LOT 9 Approved Septic System Plan
Howard County Health Department
B20004510
Septic system approved
to serve 7-bedroom
Signature
4/9/2021

WELL NUMBER: HO-17-0321
ADDRESS: 15649 LINDEN GROVE LANE
WOODBINE, MD 21797

PLOT PLAN
LOT 11
LINDEN GROVE
LIBER 1619, FOLIO 341
PLAT NO. 25071
ELECTION DISTRICT No. 4
HOWARD COUNTY, MARYLAND

15649 Linden Grove Lane * Revised Floor Plans

BASEMENT FOUNDATION PLAN SCALE: 1/4" = 1'-0"

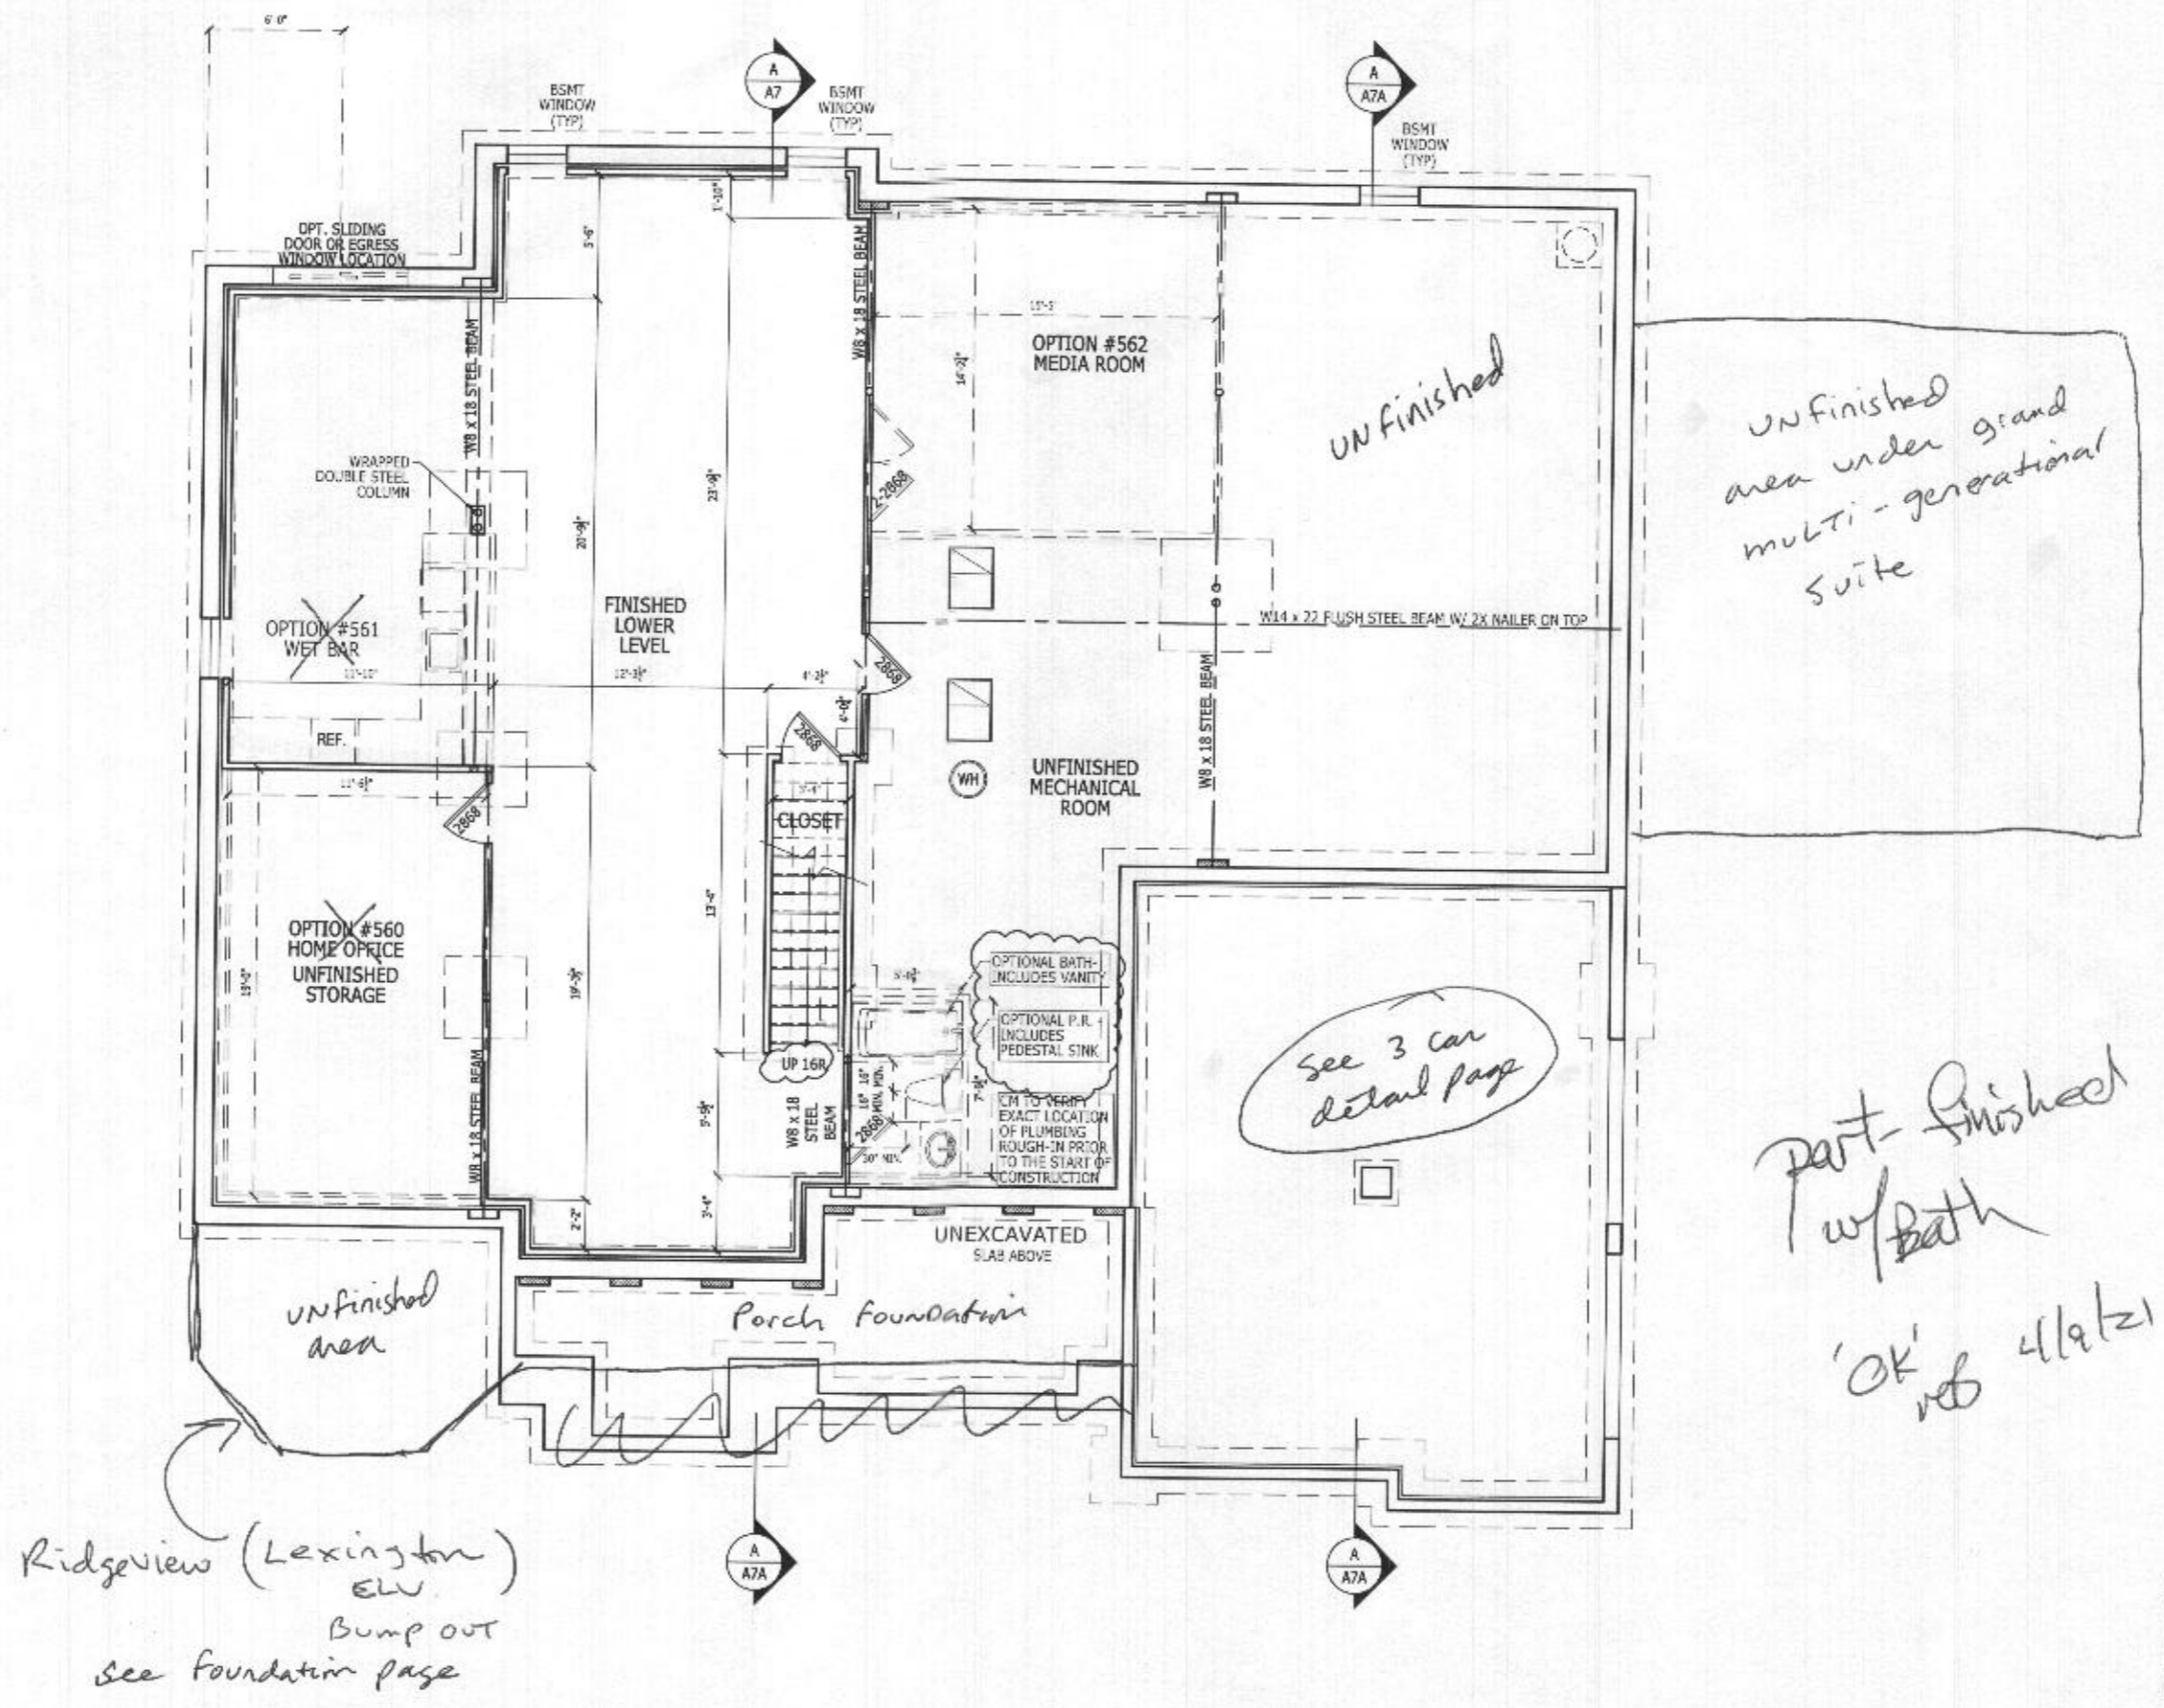
UNFINISHED area below Grand multi-generational Suite See detail page

Includes BATH see next page. potential future bedroom

'OK' red 4/19/21

OPTION 013 - BASEMENT FLOOR PLAN
Scale: 1/4" = 1'-0"

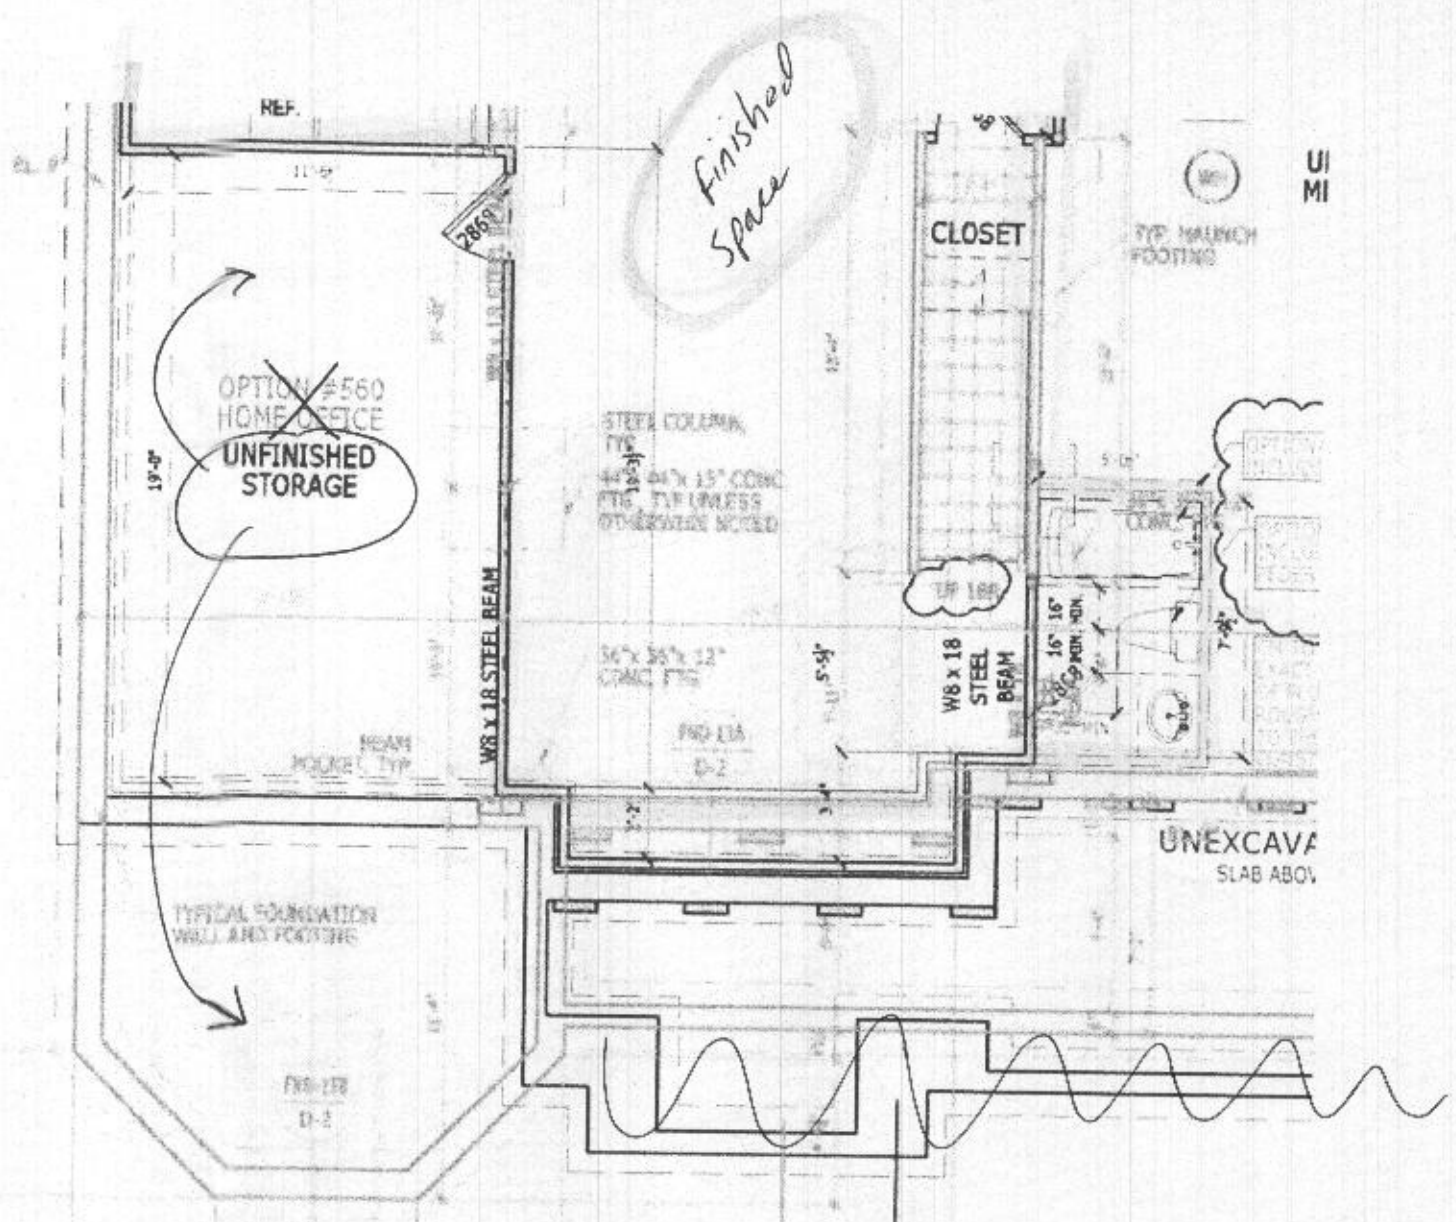
Ridgeview (Lexington) EW
Bump out
See foundation page

SHEET DESCRIPTION FINISHED LOWER LEVEL		SHEET REVISION INFO AO 211064		TOLLARCHITECTURE	
SERIAL NUMBER		SET REVISION INFO ECL 186428 01/29/18 D.BUTARUJ.VOICHECK		PHILADELPHIA · ORLANDO DALLAS · LOS ANGELES · SEATTLE	
FINISHED LOWER LEVEL		PRODUCT LINE RIDGEVIEW		250 Gibraltar Road, Horsham, PA 19044 P 215-293-5300 F 215-293-5314 A Division of Toll Brothers	
SHEET NUMBER 013		DRAWN BY - R.DAUTRICH CHECKED BY - R.DASILVA SHEET DATE - 06/16/17		ELEVATION NAME ELEV	
1015.1		part-finished w/bath OK' w/ 4/19/21

Partial Detail
Ridgeview (Lexington ELV)

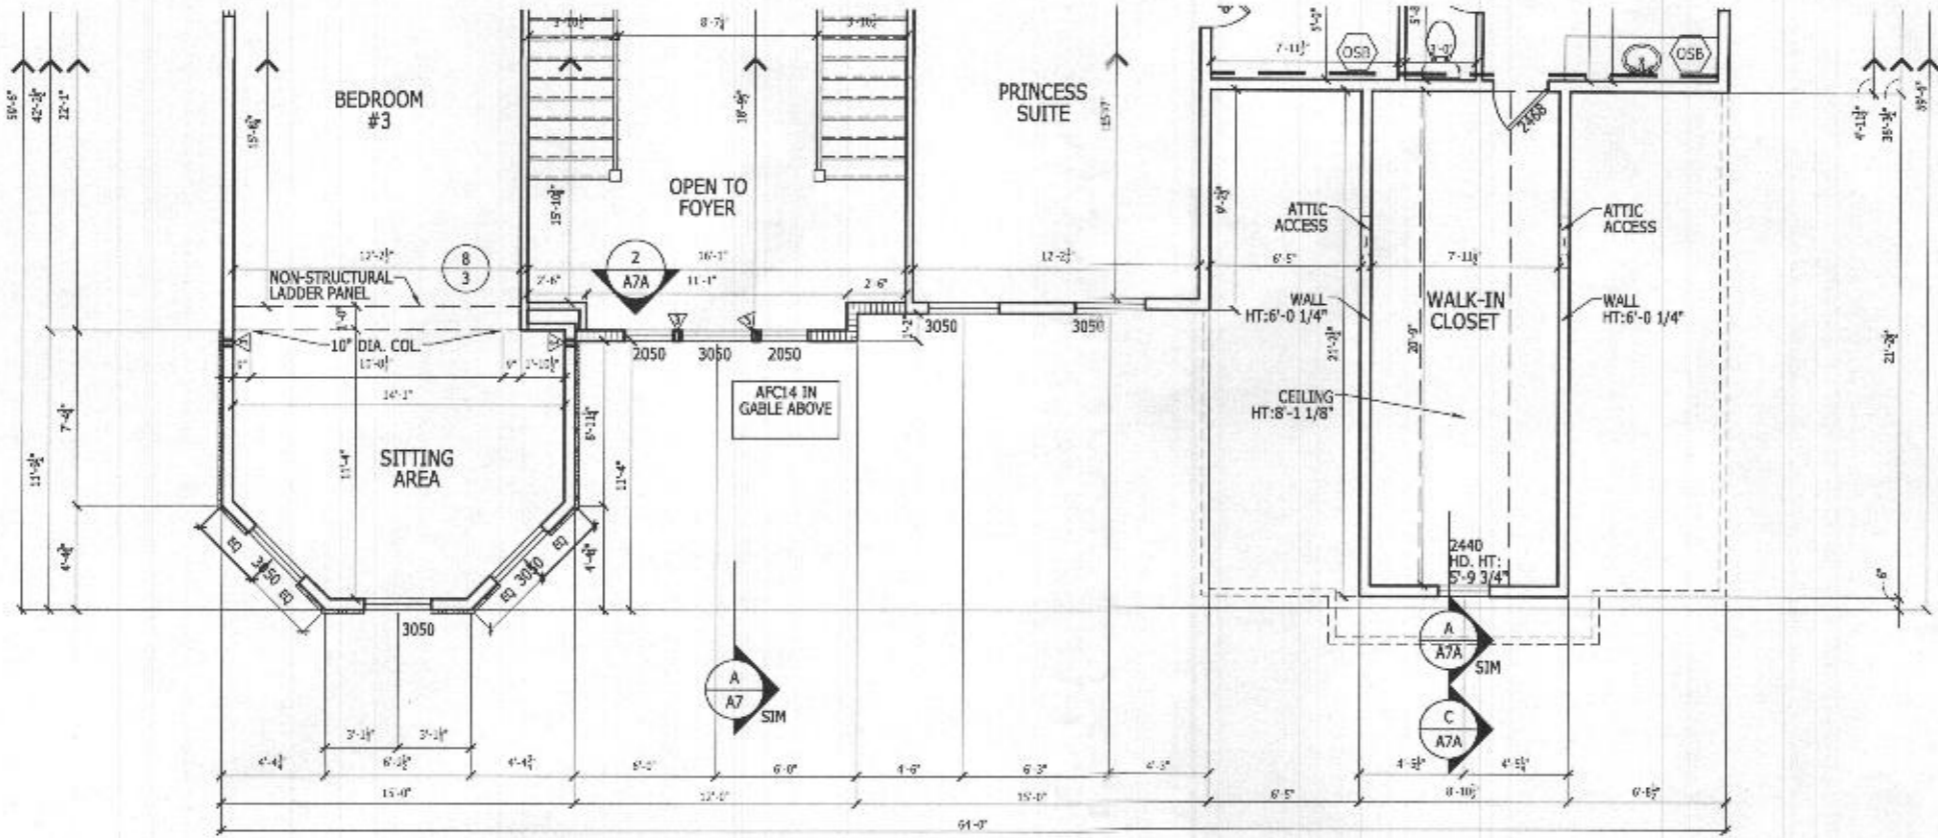
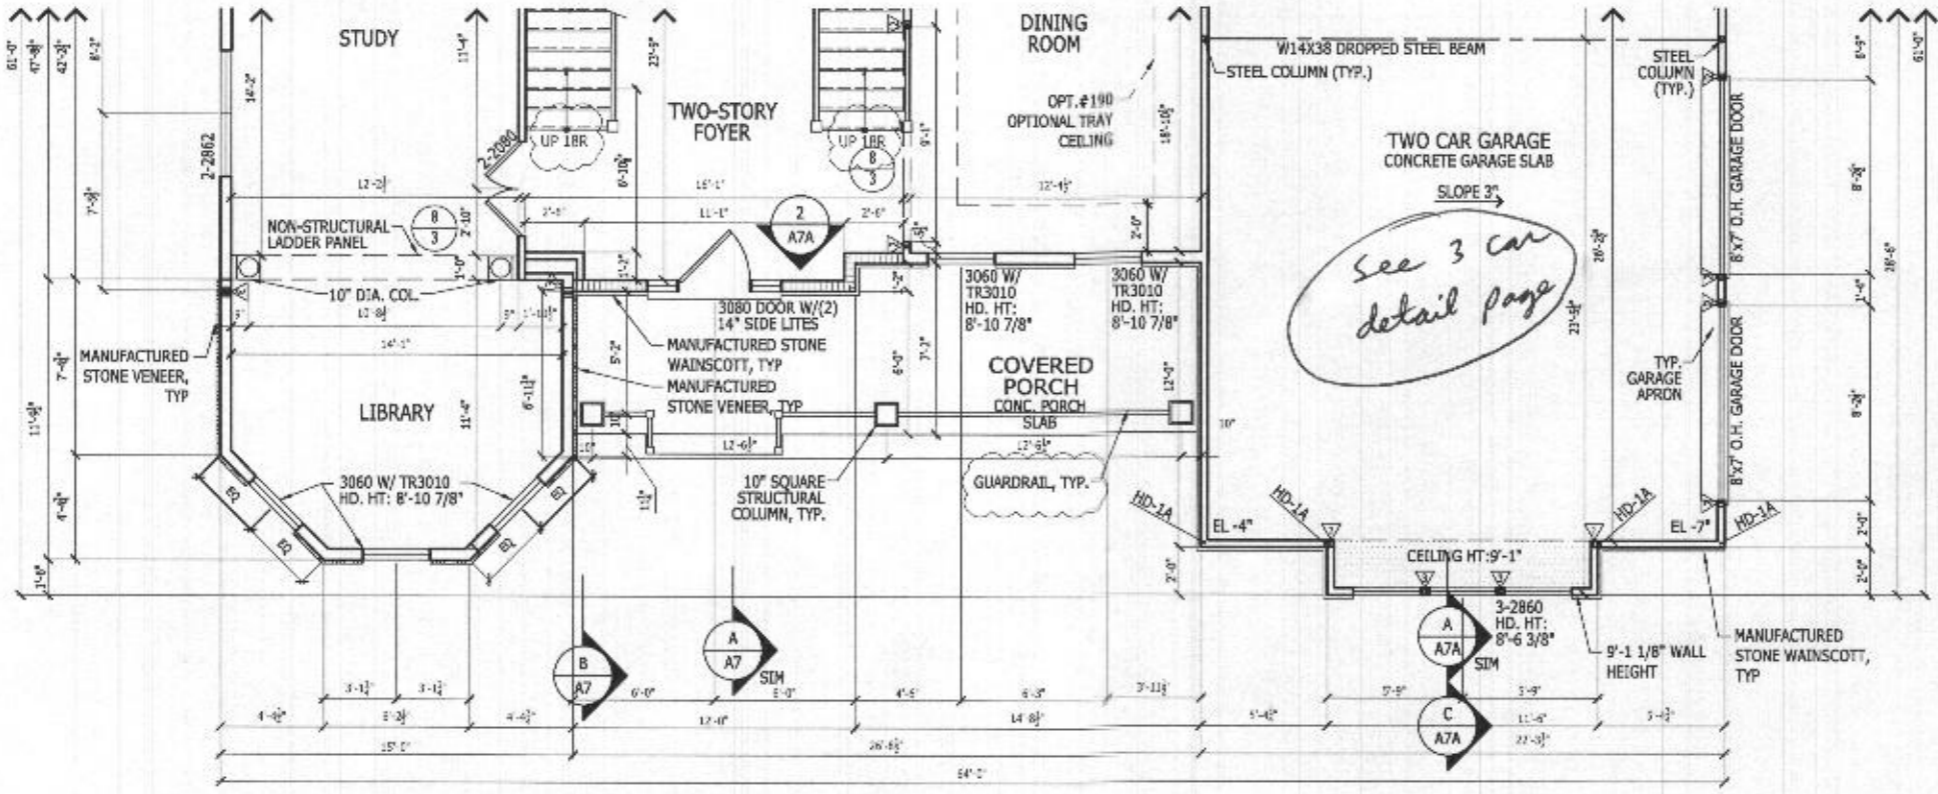
'OK'
RB 4/9/21
